Rezoning Application: PD 24-0579
Zoning Hearing Master Date: August 19, 2024
BOCC Hearing Meeting Date: October 8, 2024

**Hillsborough
County Florida**

Development Services Department

1.0 APPLICATION SUMMARY

2.4 Proposed Site Plan (partial provided below for size and orientation purposes. See Section 8.0 for full site plan)

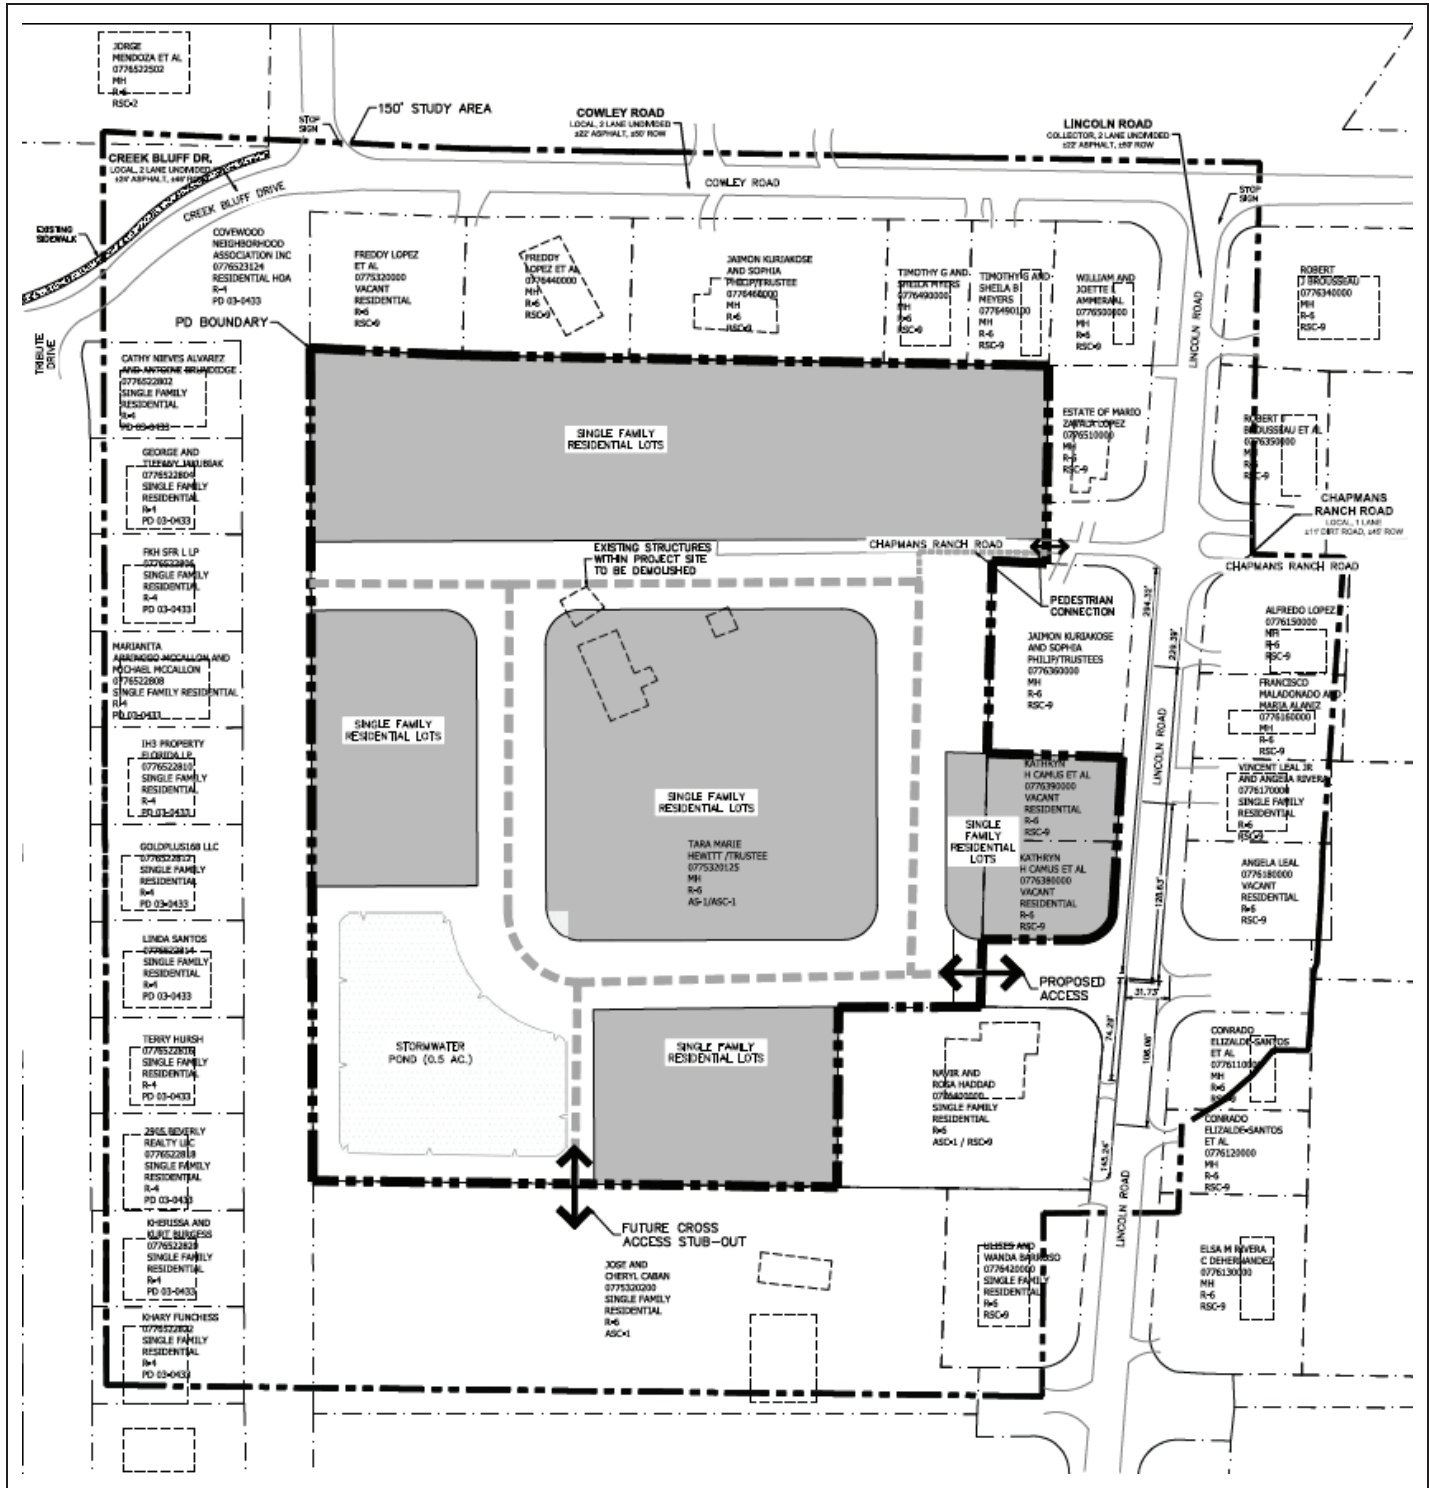
Prior to PD site plan certification, the developer shall revise the PD site plan to:

1. Add a note on the site plan that reads "Sidewalks to be provided per the LDC."

435 Feet of Additional Sidewalk

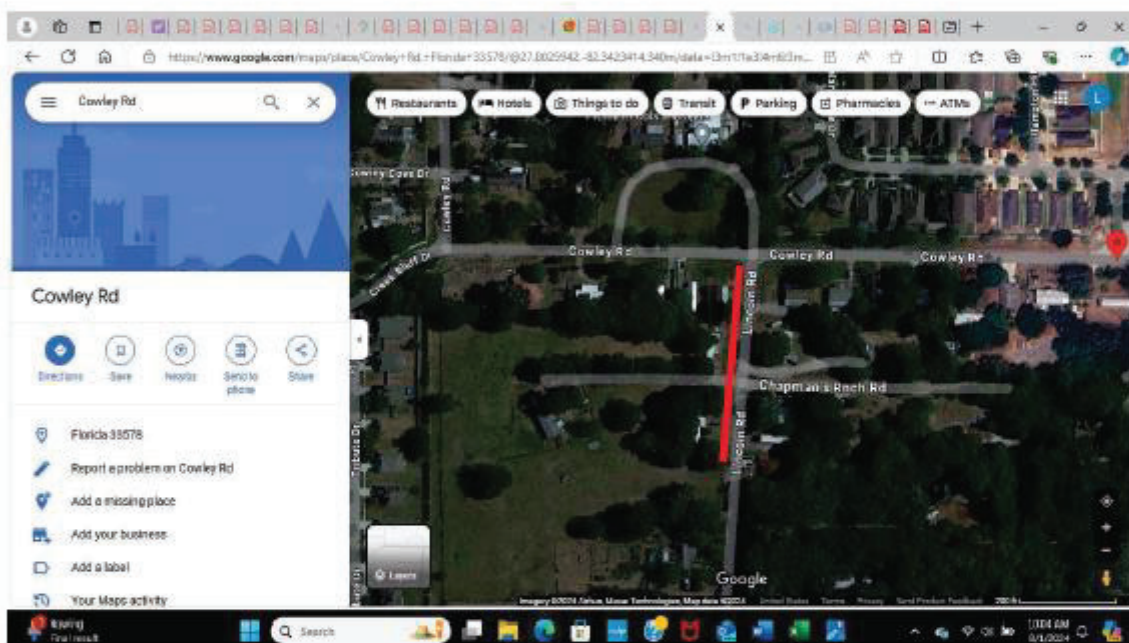
The subject property is in for rezoning, as is shown on the attached **Site Plan**. The rezoning request is from RES-6 to PD, to allow for the development of up to 41 single family homes. This request is a Design Exception to the Hillsborough County Transportation Technical Manual per section 1.7.2 to meeting Land Development Code Section 6.04.03.I – Existing Facilities. This Design Exception is to request that the developer not be required to bring Lincoln Road *fully* up to Hillsborough County Transportation Technical Manual (TTM) standards, but to instead allow for some reasonable improvements as described herein.

435 Feet of Additional Sidewalk

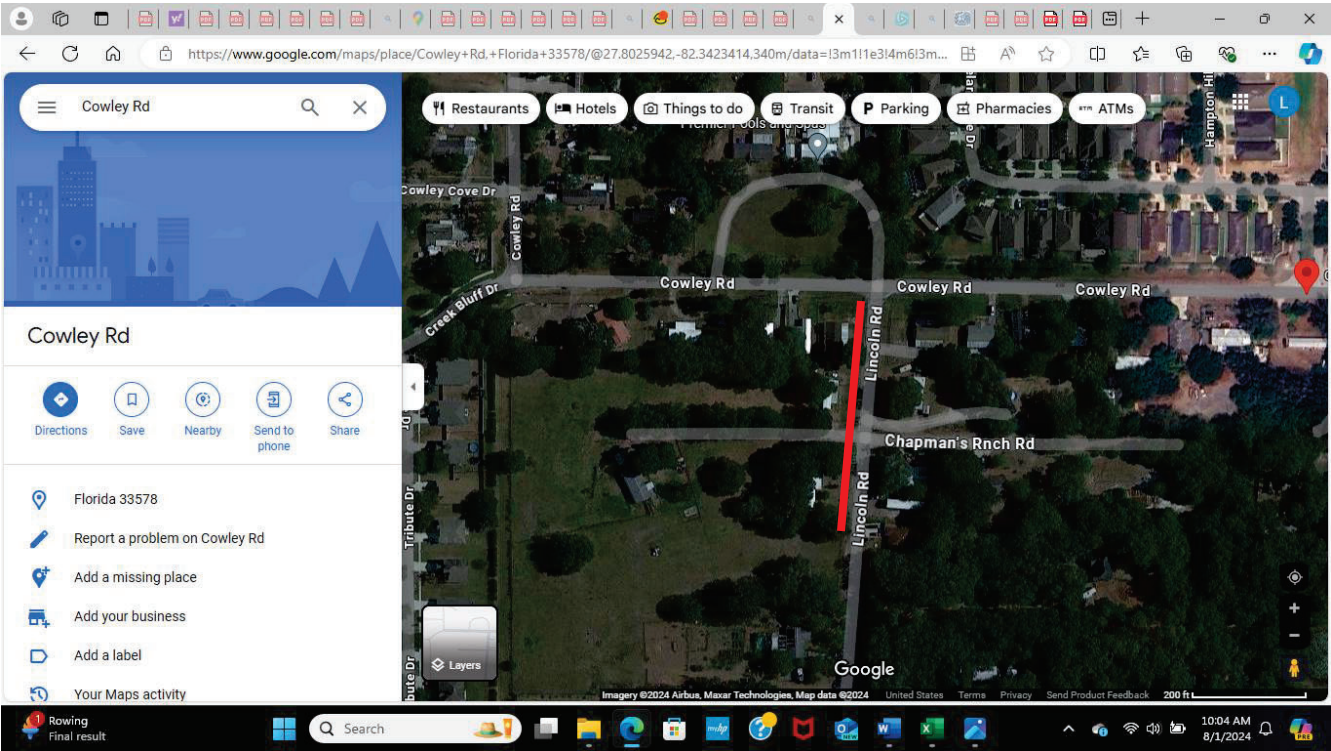
3. *JUSTIFICATION FOR THE REQUEST* – (a) There are speed humps along Lincoln Road that have presumably been constructed because of the speed and volume of cut through traffic between Cowley Road and Big Bend Road. For this reason it would be counter-indicated to make improvements that would increase the speed of relative “attractiveness” of Lincoln Road, but a pedestrian improvement is not counter-indicated. (b) The proposed improvements enhance safety as compared to the existing condition. (c) There is not sufficient right-of-way to bring the roadway completely up to TS-7 standards.
